<b>SERVICE BULLETIN</b>	
	<b>Flight Design GmbH</b> Sielminger Str. 65 D-70771 L.-Echterdingen Tel +49 (0)711 90287-0 Fax +49 (0)711 90287-99 E-Mail: <a href="mailto:info@flightdesign.com">info@flightdesign.com</a>	<b>SB-ASTM-CT__-02; SB-ASTM-CT2k-03;          SB-ASTM-CTSW-05          Revision 1</b>
		Date of Initial Publication: <b>15-Oct-2008</b> Publication Date of this Revision: <b>15-Oct-2008</b>

### Inspection of Neuform 3-Bladed Variable Pitch Propeller Installation

**SB-ASTM-CT\_\_-02;  
 SB-ASTM-CT2k-03;  
 SB-ASTM-CTSW-05**

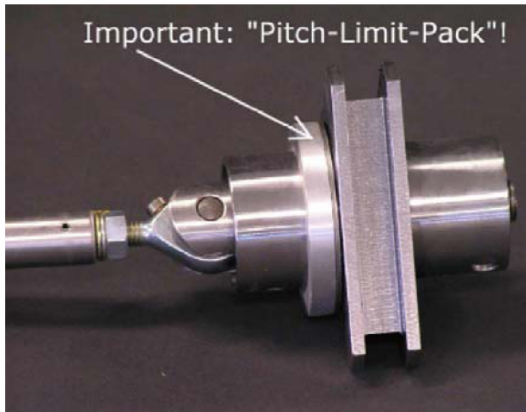
Adjustment of the propeller is done by adjustment of the actuation mechanism located behind / above the propeller gearbox. To achieve identical adjustment of the propeller after conduct of the TA and TM, the following two points have to be considered:

- The actuation mechanism, including the swivel head joints, must not be misadjusted at all. It is highly recommended to mark the position of the swivel head joints including nuts with paint.

- The pitch limiter package within the actuation rod may not be altered.

## 2.2 Conduct of TM-08-01 Neuform

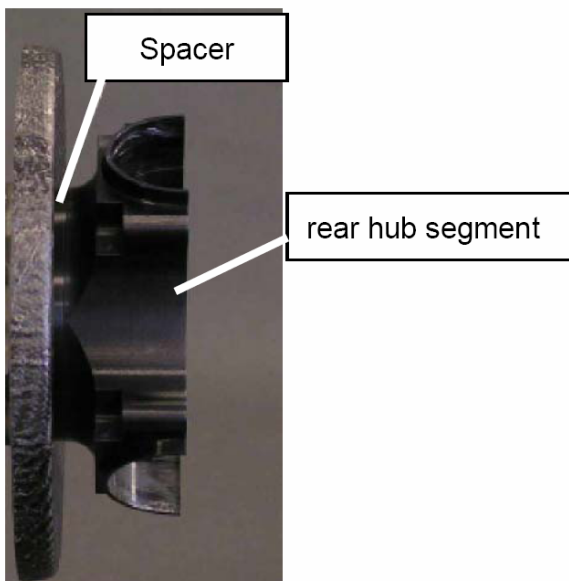
To conduct TM-08-01 Neuform it is sufficient to send the rear hub segment and the spacer to Neuform or to one of the workshops qualified by Neuform to perform TM-08-01.
